Change Notice

Changes for P Toggles with Large Bat Lever

Changes for P Toggles with 12mm Bushing & Large Bat Lever

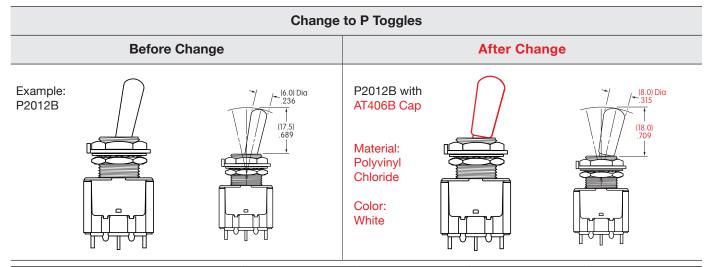
The P Series toggles with 12mm bushings and large bat levers (code B) will undergo changes to the levers. In order to maintain VDE approval, a white cap will be assembled onto the lever. This modification will apply to all standard and custom P toggles with the large bushing and bat lever. The following table illustrates differences before and after the change, and effected standard parts are listed below.

- The purpose of this change is to retain VDE approval. By installing the AT406B cap, P Toggles with the large levers maintain the VDE standard, but will lose UL and CSA recognition. Without the addition of the cap, the switches would lose the VDE approval status (UL and CSA approvals would not be effected). However, the switches will be available without the addition of the cap.
- There are no additional changes to external dimensions or specifications other than what is shown above.
- Refer to Change Notice 296-A for additional information.
- Contact the factory if further details are needed.

The P Series toggles with large bat levers and 12mm bushings (code B) are not UL and CSA recognized. For this reason, the code B type switches with UL and CSA markings will be discontinued. Without the addition of the cap (AT406B), the switches will be available but will not be approved for markings.

P Series toggles with the white capped column and 12mm bushing (code D) will be available and approved for VDE, UL and CSA.
